Host, module, and test fixture illustrations for Annex 176D

Adee Ran, Cisco

Proposed modification – Figure 176D–2

Figure 176D-2—200 Gb/s per lane AUI-C2M link diagram

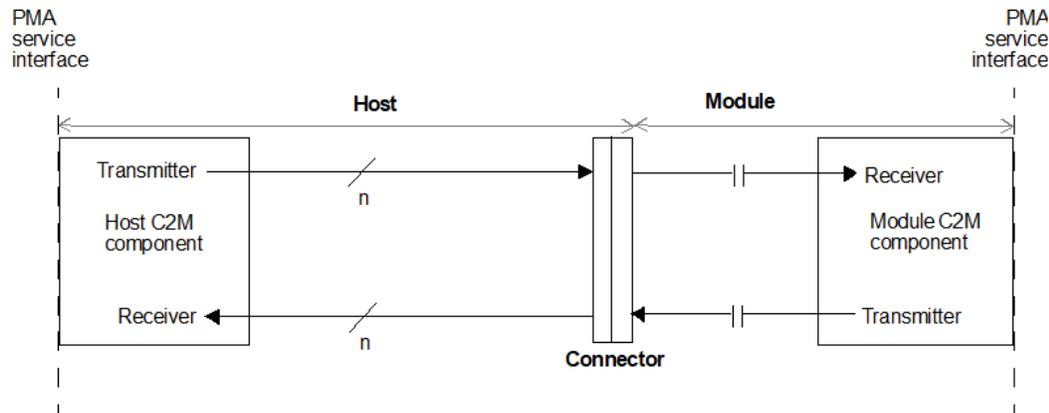
- During Working Group ballot there was a multitude of comments related to the illustrations of modules, hosts, text fixtures, especially on the “connector” label in multiple figures. The figures and notes went through multiple changes.
- Recently comment #57 against D2.3 noted inconsistency between figures, and lack of clarity of what the vertical line in the “connector” represents.

- Comment #57 was rejected due to lack of consensus (and no desire to make changes in D2.4)
- However, it was noted that “the figures addressed in the comment, and similar ones in the draft, could be improved in various ways”.
- As editor of annex 176D, I took action to create improved figures.

- The word “connector” is ambiguous
 - In dictionary.ieee.org - in IEEE Std 1680.1-2018 as "An electrical or mechanical coupling device employed to connect one element with those of another element"
 - In SFF-TA-1045 (pertinent for this annex): "Each half of an interface that, when joined together, establish electrical contact and mechanical retention between two components. In this specification, the term connector does not apply to any specific gender; it is used to describe the receptacle, the plug or the card edge, or the union of receptacle to plug or card edge. Other common terms include: connector interface, mating interface, and separable interface."
- Outside of figures, it only appears in the Annex once – in 176D.8.3 (ERL)
 - “...the first discontinuity of the AUI-C2M connector“
- Unclear terminology should be minimized

- Annex 176D does not specify any “connector”...
 - But it refers to Annex 179B for test fixtures, which are associated with “MDI connectors” – implicitly this means the same connectors.
 - In practice, hosts use the MDI receptacles of Annex 179C, and modules plug into them. There has been no discussion of other C2M connectivity in P802.3dj.
- The vertical line in the “connector” seems to represent the mating point, which is all we care about.
- The current figures are a mixture of block diagrams with electrical components and mechanical “hints”.
 - Many readers know how modules and hosts look like and how they connect – but the figures are far from being representative.
 - The proposed new figures are not mechanical drawings but should be more representative and clear.

Figure 176D–2—200 Gb/s per lane AUI-C2M link diagram

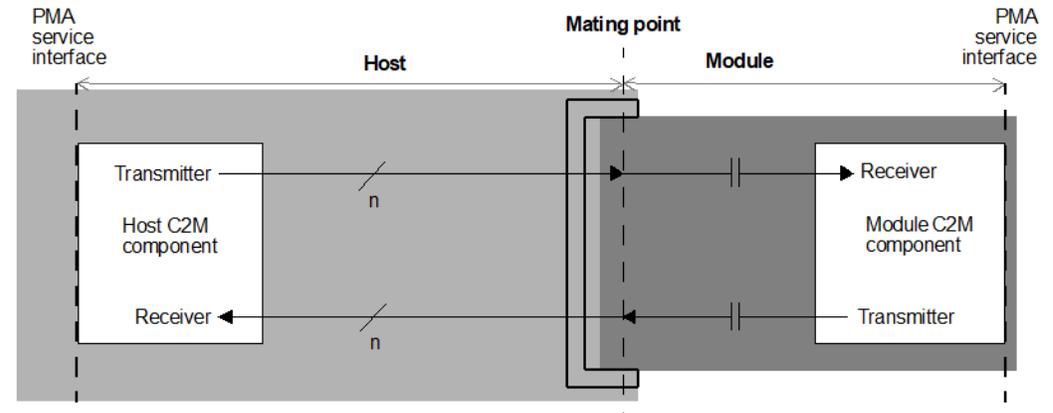
NOTE 2—The host is depicted as having a receptacle into which the module is plugged. This is based on the MDI connectors specified in Annex 179C. Other connection methods may be used.

New note points explicitly to Annex 179C

Figure 176D–4—Host compliance points

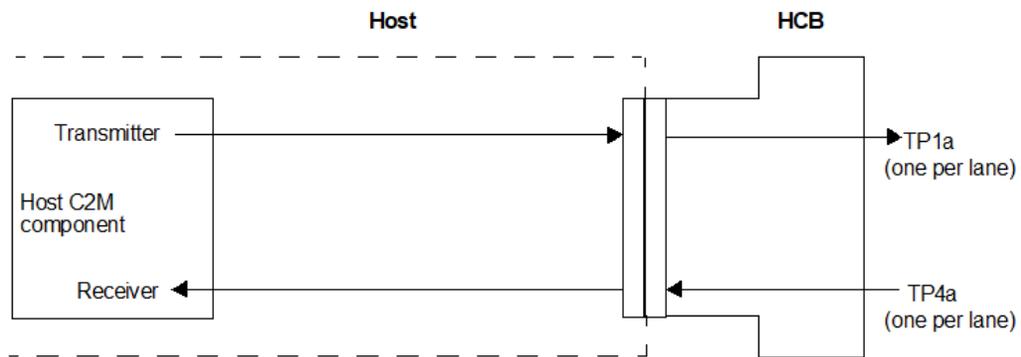
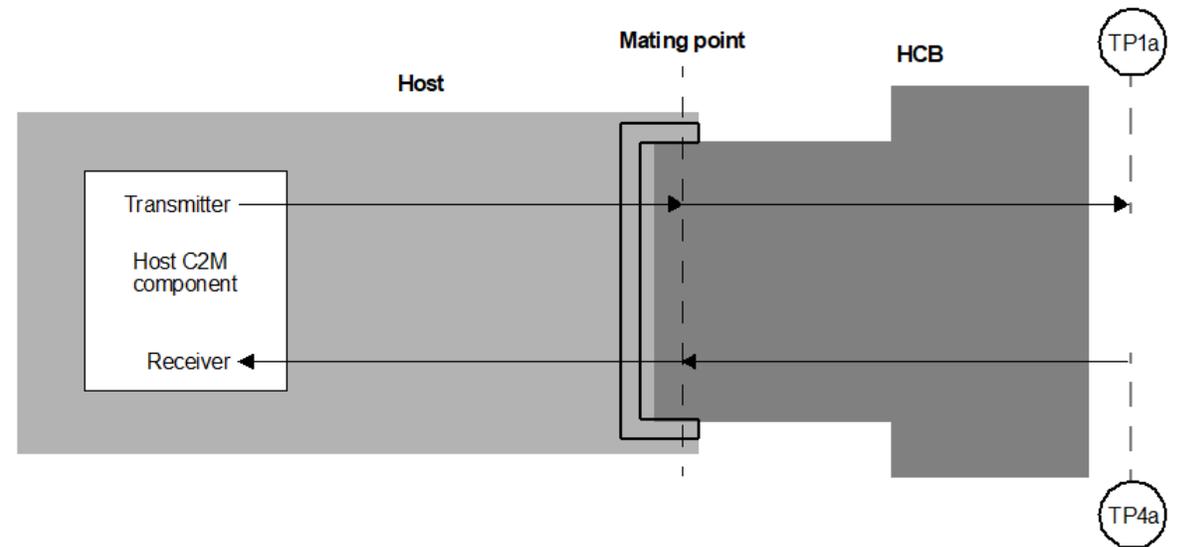
Proposed modification – Figure 176D–4

NOTE —Test points are one per lane.

Figure 176D–5—Module compliance points

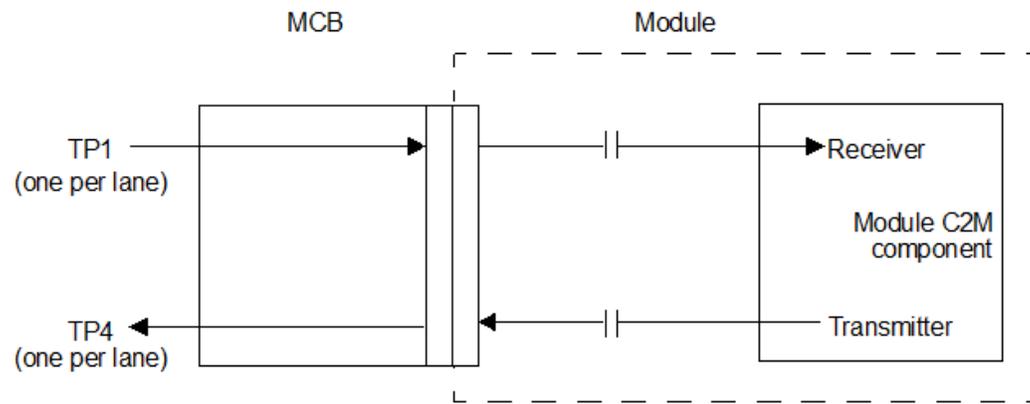
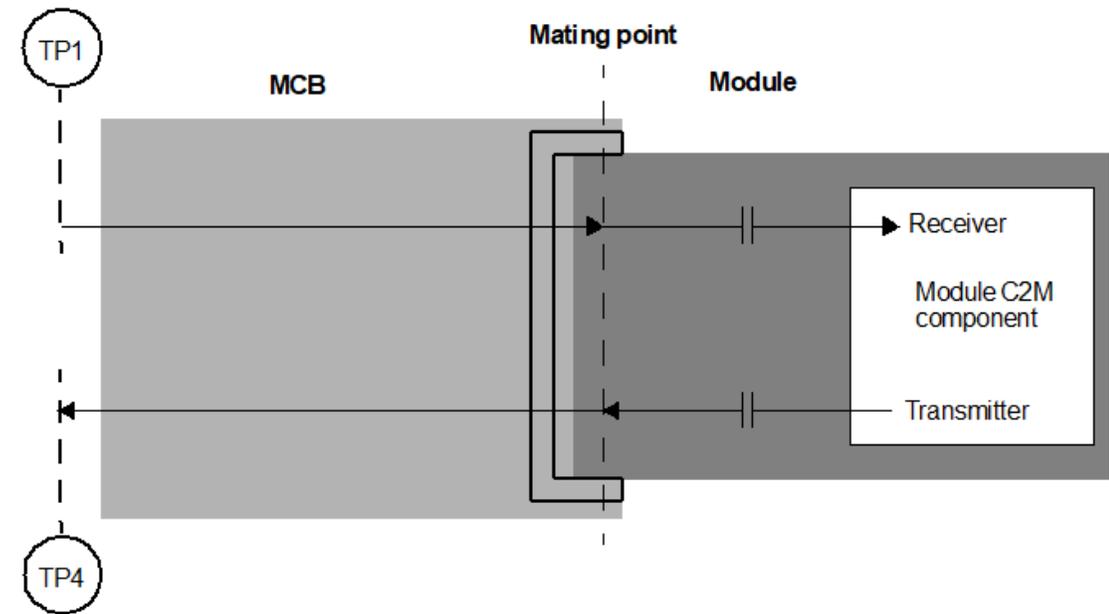
Proposed modification – Figure 176D–5

NOTE—Test points are one per lane.

Figure 176D–6—Reference insertion loss budget at 53.125 GHz

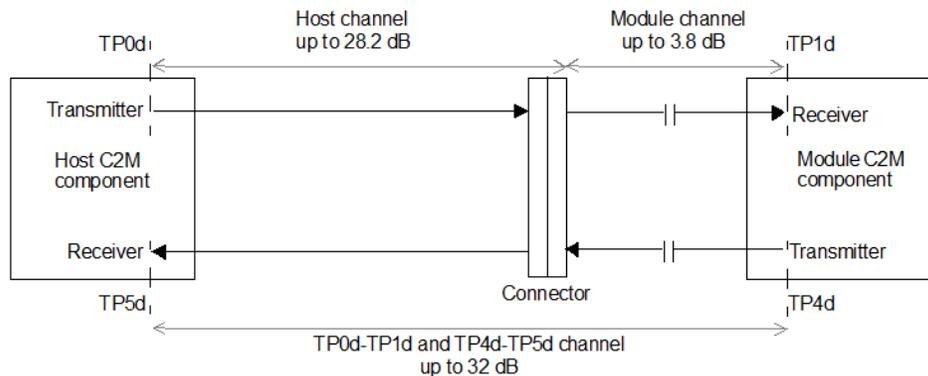
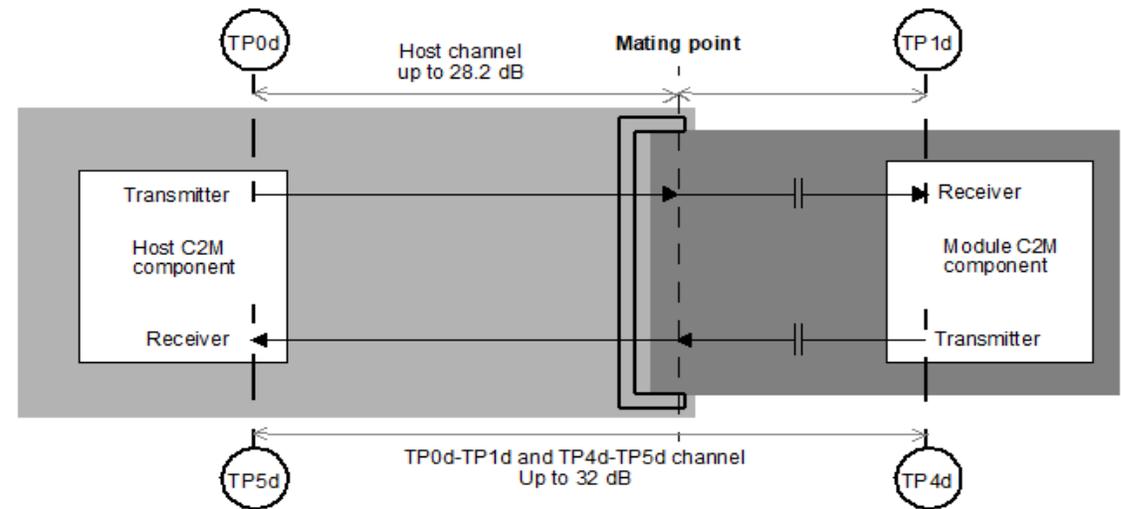
Proposed modification – Figure 176D–6

The note in the existing figure is not needed anymore – it is evident in the new figure.
